DEPARTMENT OF PLANNING & SUSTAINABILITY

STAFF ANALYSIS

Case No.:	CZ-25-1247294	File ID #: 2024-1442	
Address:	1716 Pleasant Hill Trail, 7778, 7860, 7890, 7900, 7956 & 8024 Pleasant Hill Road	Commission District: 05	Super District: 07
Parcel ID(s):	16-197-03-006, 16-197-03-012, 16-219-01-005, 16-219-01-006, 16-220-01-004 16-220-01-007 & 16 220 01 009		
Request:	Major modification of Conditions #1 and #4 of CZ-18-22130 for the development of single-family detached dwellings within the RNC (Residential Neighborhood Conservation) Zoning District.		
Property Owner(s):	Hybrass Properties, LLC.		
Applicant/Agent:	Hybrass Properties, LLC. c/o Battle Law, P.C.		
Acreage:	95.52 acres		
Existing Land Use:	Single-family dwellings/vacant		
Surrounding Properties:	North: R-100, MU-1 East: RNC, R-85 South: R-85 West: R-85		
Comprehensive Plan:	Suburban (SUB)	Consistent	Inconsistent X

Staff Recommendation: TWO-CYCLE DEFERRAL

CONCEPT PLAN
FOR
PLEASANT HILL

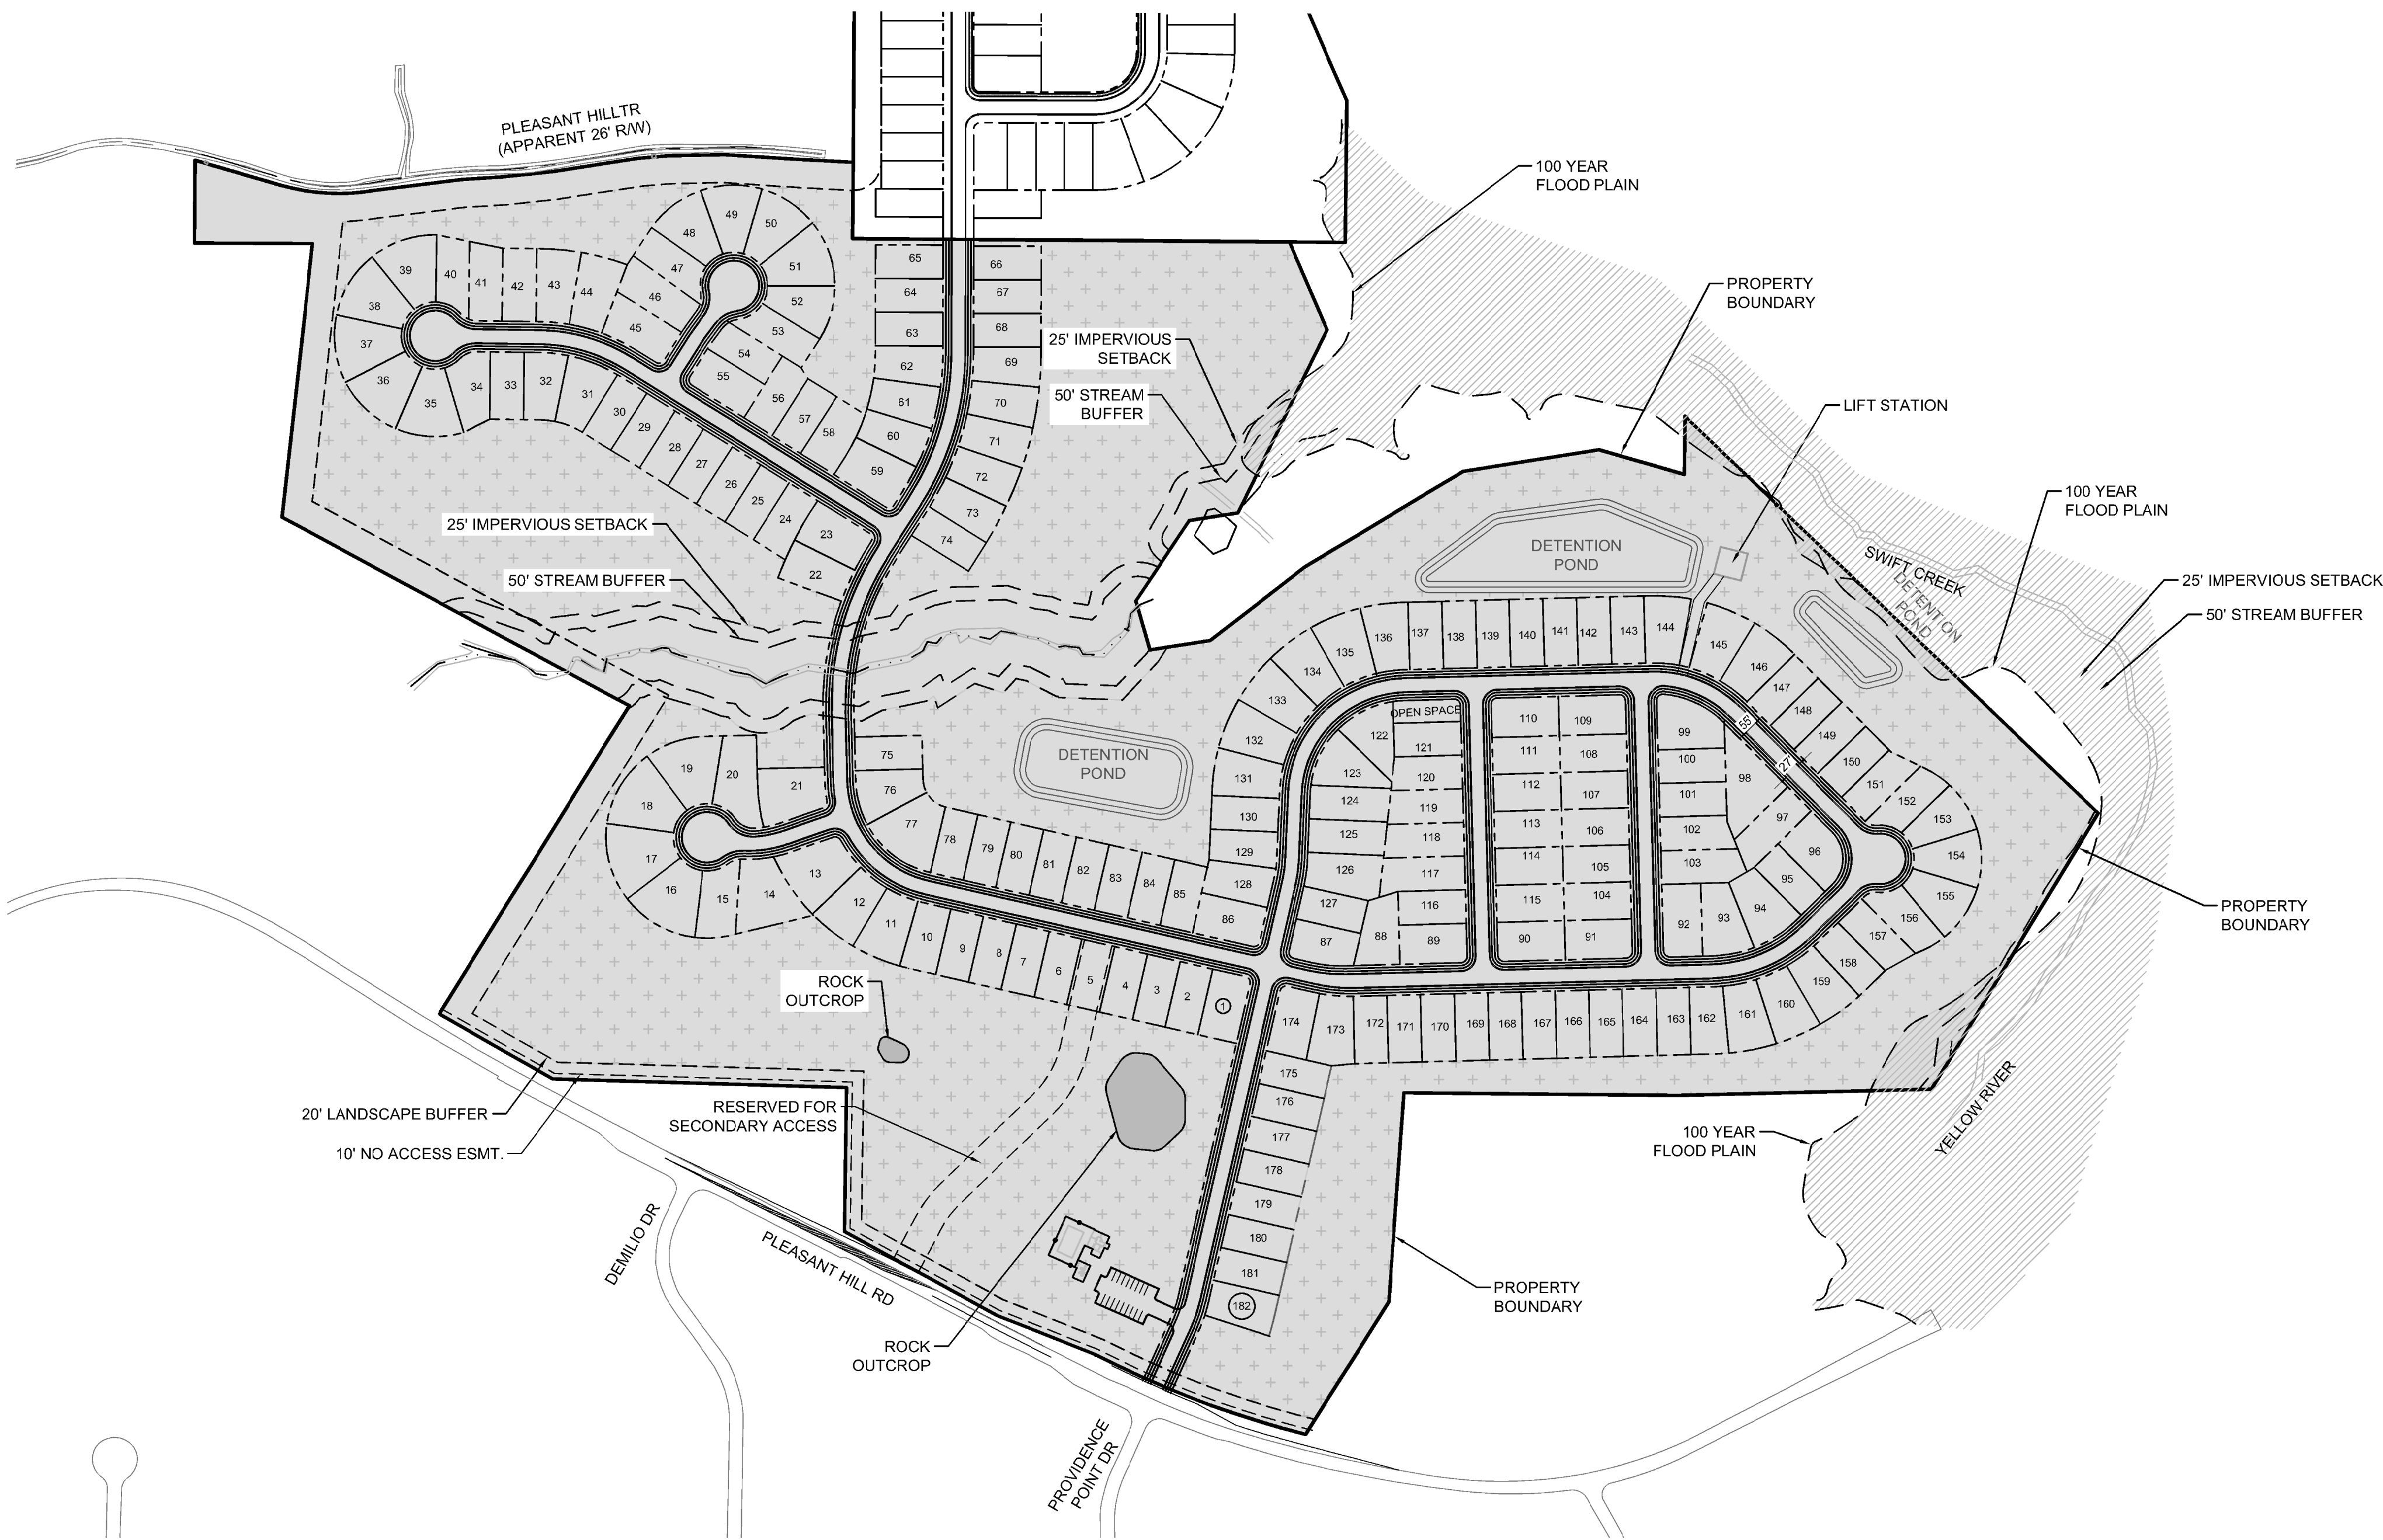
While the reduction of units allows for the potential preservation of greenspace that is encouraged with RNC developments (see Section 2.10.2. of the *Zoning Ordinance*), there are still potential issues with topography that may affect the configuration and/or potential lot yield with the development. Namely, the new site plan does not appear to prove compliance with the minimum greenspace requirement as defined per Section 2.10.5. of the *Zoning Ordinance*. A minimum of 30 percent of the total site area shall be dedicated to greenspace, which may not consist of the following features (per Section 2.10.5.(B)):

The submitted site plan shows a development that appears to have extreme slopes throughout, as well as having state waters/stream buffers. Meeting this greenspace requirement could pose a challenge for development and could affect lot yield.

1. Compliance with the Georgia Stormwater Management Manual, DeKalb County Code of Ordinances 14-40 for Stormwater Management and 14-42 for Storm Water Quality Control, to include Runoff Reduction Volume where applicable, is required as a condition of land development permit approval. Use Volume Three of the G.S.M.M. for best maintenance practices. Use the NOAA Atlas 14 Point Precipitation Data set specific to the site. Recommend Low Impact Development features/ Green Infrastructure be included in the proposed site design to protect as much as practicable the state waters and special flood hazard areas.

2. The county codes require the hydrology study to model the existing conditions as wooded
3. Runoff Reduction Volume shall be provided unless technical justification is provided regarding the unfeasibility. Strongly recommend investigating the site and identifying the location where RRv can be provided and re-designing/revising the layout to comply with the RRv requirement.

6. The state water buffer was reflected in the G.I.S. records for the site. Typical state waters buffer have a 75' undisturbed stream buffer and land development within the undisturbed creek buffer is prohibited without a variance per DeKalb County Code of Ordinances 14-44.1.

7. The internal street(s) must be at least 24' for the travel lanes (2 x 12') and have a R/W of 55' at a minimum

The majority portion of the parcels are outside the floodplain but there exists FEMA designated Special Flood Hazard Areas on the fringe of properties at the northeast portions of the listed parcels. Compliance with the floodplain management and flood damage prevention ordinances is required and also, adequate erosion and sedimentation and pollution control measures will be required for any proposed development in this area.

N5. CZ-25-1247294 - 7778 Pleasant Hills Road, etc. - Phase 1 has 182 lots and requires 3 access points (Sec. 14-200 (5)). Verify the reserved secondary access point meets the minimum spacing outlined in 14-200 (6) and has the required sight distance. Please see infrastructure requirements in Zoning Code 5.4.3 and Land Development Code 14-190. Pleasant Hill Road is a classified as a minor arterial (45MPH). Requires a right of way dedication of 40 feet from centerline OR such that all public infrastructure is within right of way, whichever greater. Requires at least an 11-foot travel lane with curb and gutter. Requires a 10-foot landscape strip (with at least 5 feet between the back of curb and the sidewalk/path), 6-foot sidewalk with 4-foot bike lanes OR (preferred) 10-foot multiuse path in lieu of sidewalk and bike lane. Street Lighting required. (hefowler@dekalbcountyga.gov). Pleasant Hill Road is classified as a local road. Requires a right of way dedication to 27.5 from centerline OR such that all public infrastructure is within right of

As a result of meetings with Current Planning Staff, the applicant has requested a deferral of the proposal to revise their site plan and provide additional information. In coordination with the applicant's request, the Planning and Sustainability Department recommends a *Two-Cycle Deferral* to address the above issues.
